Date January 22, 2020 **Report No.** 2020-47

Committee of Adjustment Decision Regarding Applications for Consent and Minor Variance

APPLICATION NO.	B26/2019, B27/2019 & A27/2019
AGENT	J.H. Cohoon Engineering Ltd.
APPLICANT/OWNER	Frank J. Zamboni & Co Limited
LOCATION	38 Morton Avenue East

Concept Site Plan – Lots 1 and 2

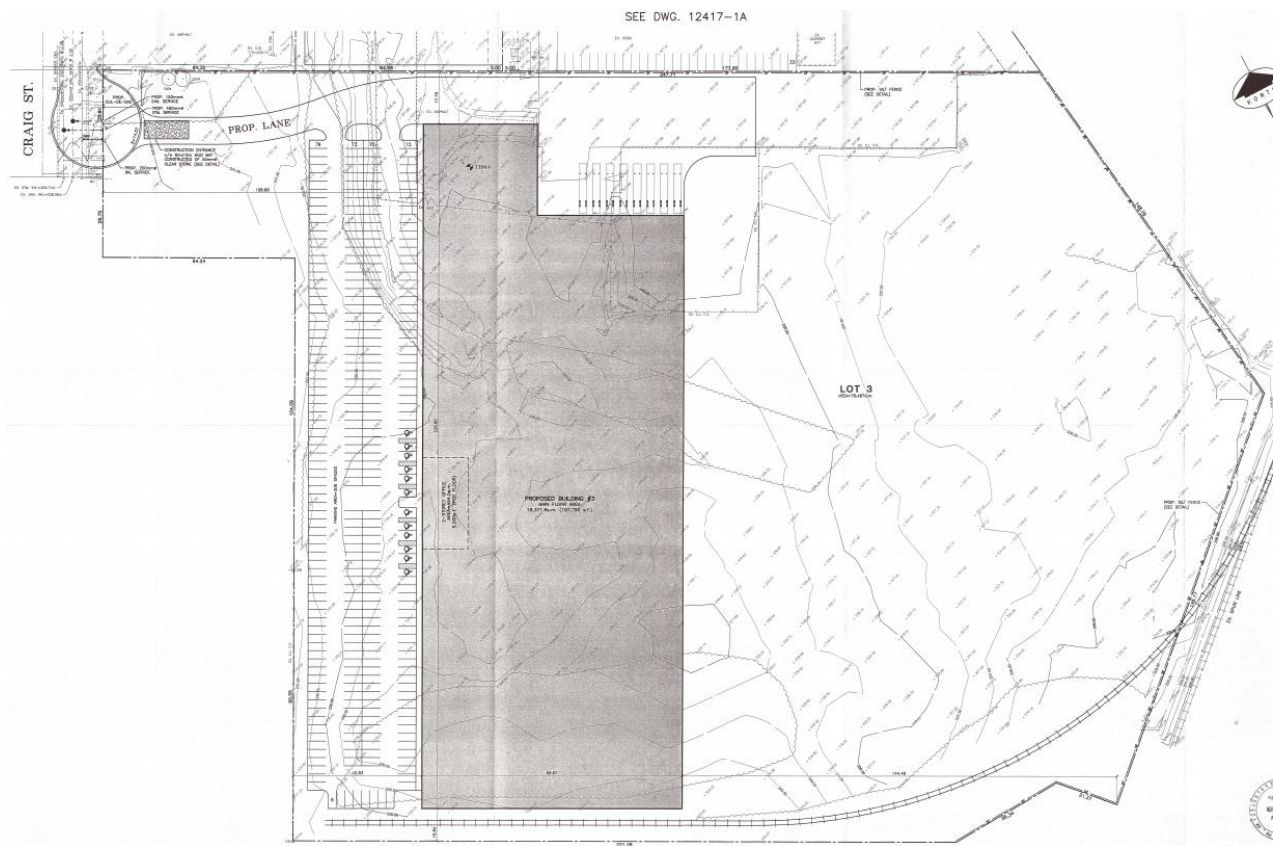
Transportation and Parking Services Staff has also requested a continuous path and turning movement plan illustrating the ingress and egress of the proposed driveway for Lot 1 and 2 in order to ensure the functionality of the access and to avoid any additional Planning applications to revise the proposed access easements after the Certificate of Official has been issued. The condition will apply to application B26/2020 and is outlined in **Appendix A1** of this Report.

2. At such time that additional information is provided as per comment #1, conveyance of land to the Craig Street right-of-way (ROW) will be required.
3. Continuous path turning movement analysis should be provided for ingress/egress at the proposed shared access easement via Morton Avenue in order to avoid revisions to the easement through future applications.

6. ☒ Receipt of confirmation from General Manager of Public works confirming their requirements have been satisfied regarding the receipt and approval of a continuous path and turning movement plan respecting the ingress/egress at the proposed shared access easement;
